CATO RIDGE LAND DEVELOPMENT AND RELEASE PROJECT– COMMENTS AND RESPONSES REGISTER

The following is a summary of the comments received to date. The project team have taken note of the concerns/comments and responded as necessary for onward communication to the relevant I&AP.

ASSMANG LANDHOLDINGS, CATO RIDGE, KWAZULU-NATAL: BIODIVERSITY OFFSET REPORT

RESPONSE TO COMMENTS RECEIVED BY KZN-EDTEA, EKZNW AND EBMB

Figure 1: Proposed new Harrison Quarry Access

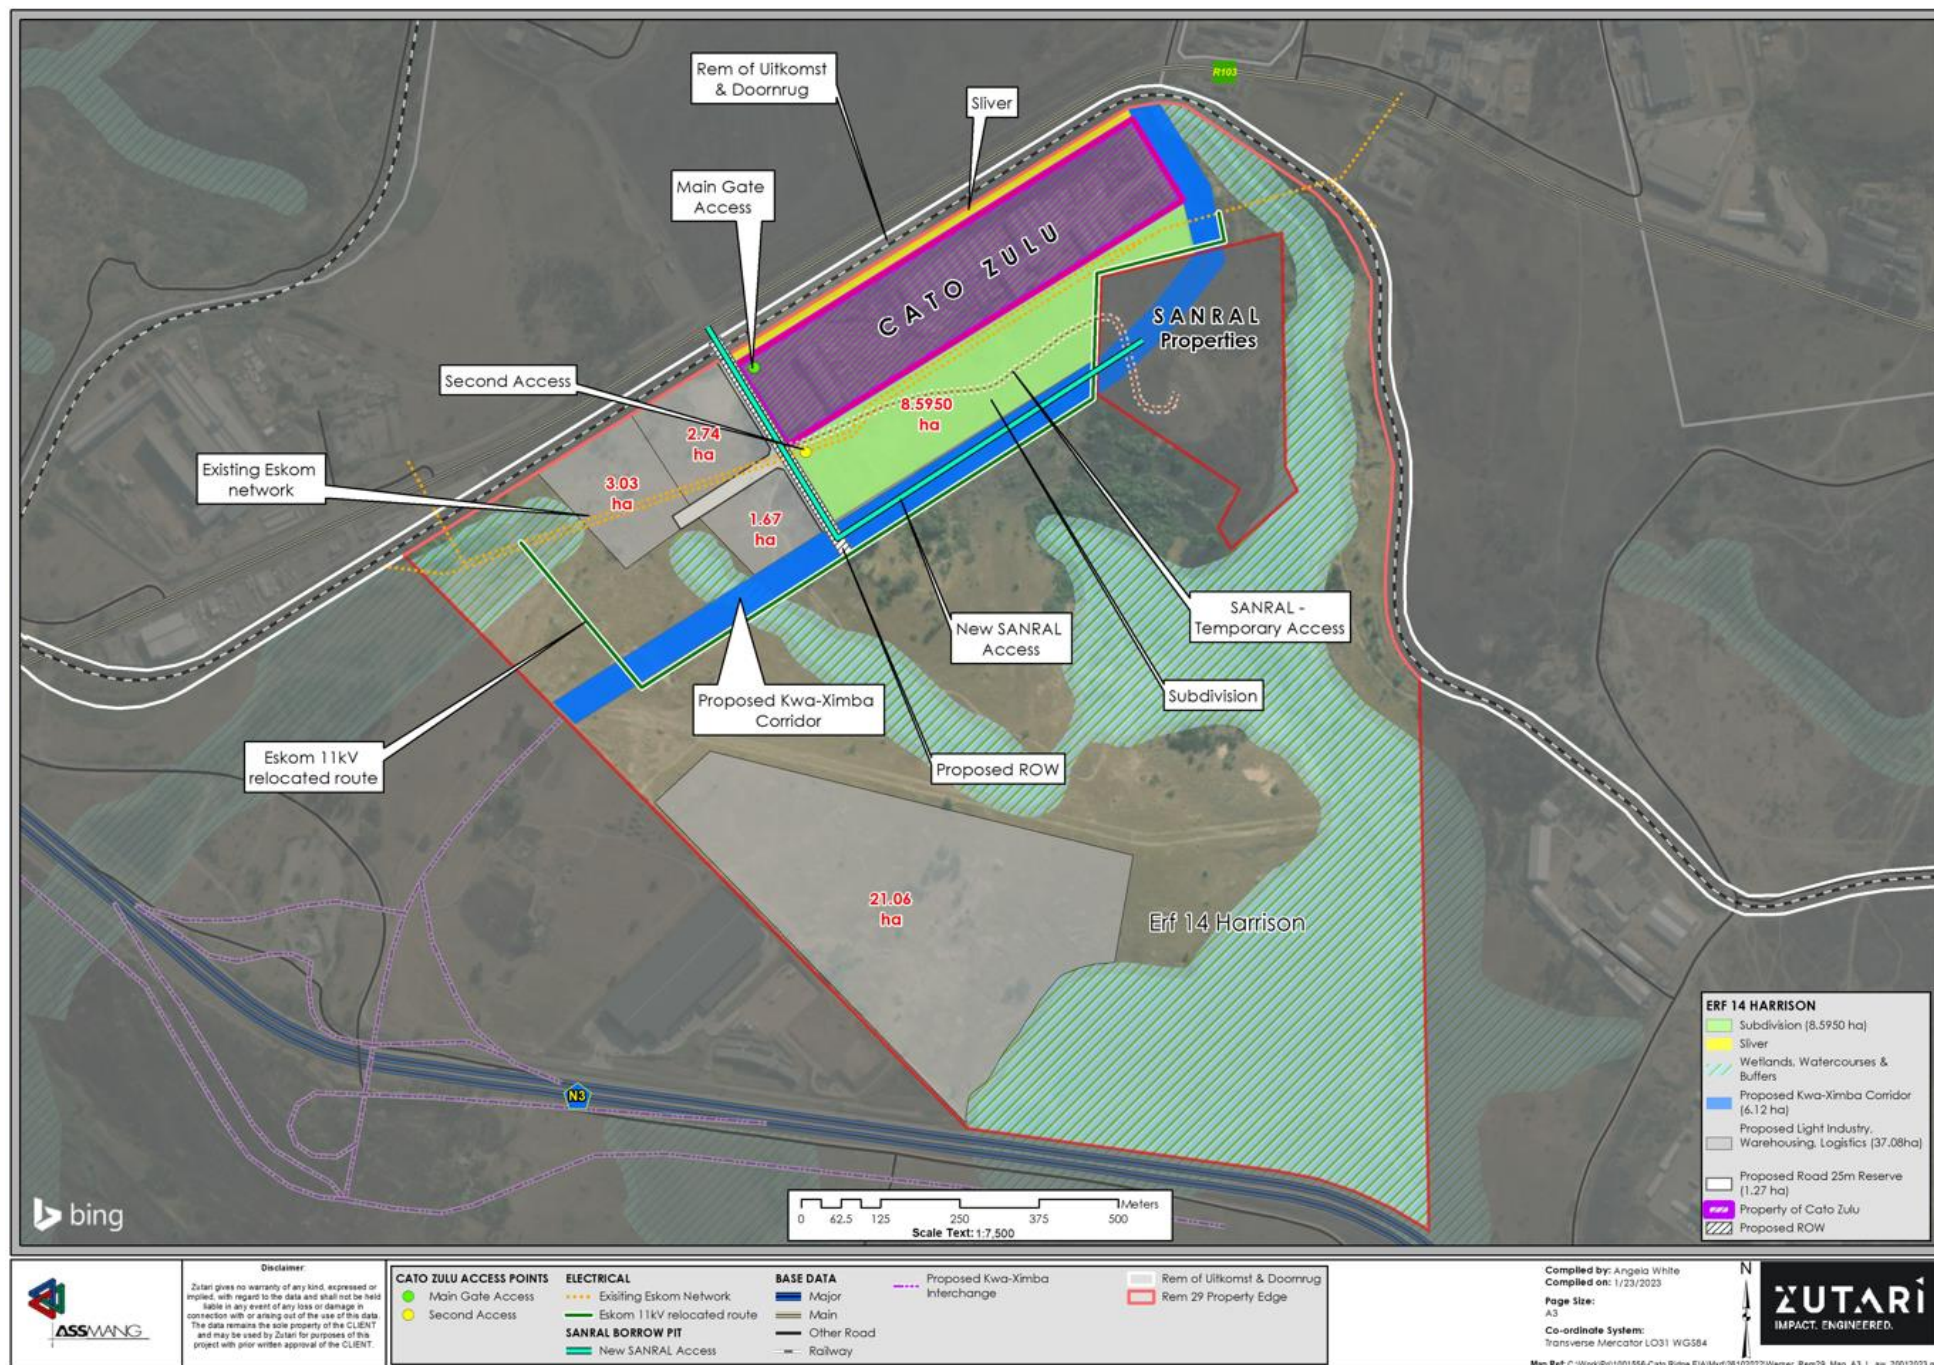
Issue	Name	Format	Date	Question / Comment	Response (EAP, Applicant, Specialists and Engineers)
				routes (considering made to road reserve), mode of PT service required to service the peak demands, the vehicle fleet size and service frequencies. c. The assessment does not include the required infrastructure plans which would align to the PT service and commuter needs. Maps and diagrams off proposed PT infrastructure locations is inadequate. D. The infrastructure plan must include detailed conceptual design plans for all PT facilities associated with this development (origin and destination facilities as well as PT stops enroute). e. Land set aside for PT facilities should be clearly demarcated on the development precinct plans for all PT facilities as part of the town planning layout proposal. Public Transport servitudes are to be registered on sites housing PT facilities (ranking and holding). f. The assessment must also provide the roles and responsibilities for either or both the funding and construction of the requisite PT infrastructure noting that certain assets are not municipally owned. Should you have any queries or require clarity in respect to the above comments, please do not hesitate to contact the Public Transport Planning branch. 6. Traffic Engineering Branch comments: - a. KwaZulu Natal Department of Transport (KZN DoT) and South African National Roads Agency Limited (SANRAL) must comment on this application and Traffic report, since all roads within the study area are currently under the jurisdiction of KZN DoT and SANRAL. b. All internal road infrastructure, intended to be handed over to the Municipality, must meet minimum engineering standards in consultation with ETA and Roads Provision Department.	c. Noted by specialist and will be included in future work. d. Noted by specialist and will be included in future work. e. Noted by specialist and will be included in future work. f. Noted by specialist and will be included in future work. Thank you for the comments, project role players will communicate with Public Transport Planning branch with any matters pertaining. 6. a. SANRAL and KZN DOT have been approached for comment on the draft EIR. b. Internal roads will be designed to relevant Municipal standards. Engagement will be undertaken with ETA to determine if and which precinct roads will be handed to the municipality.
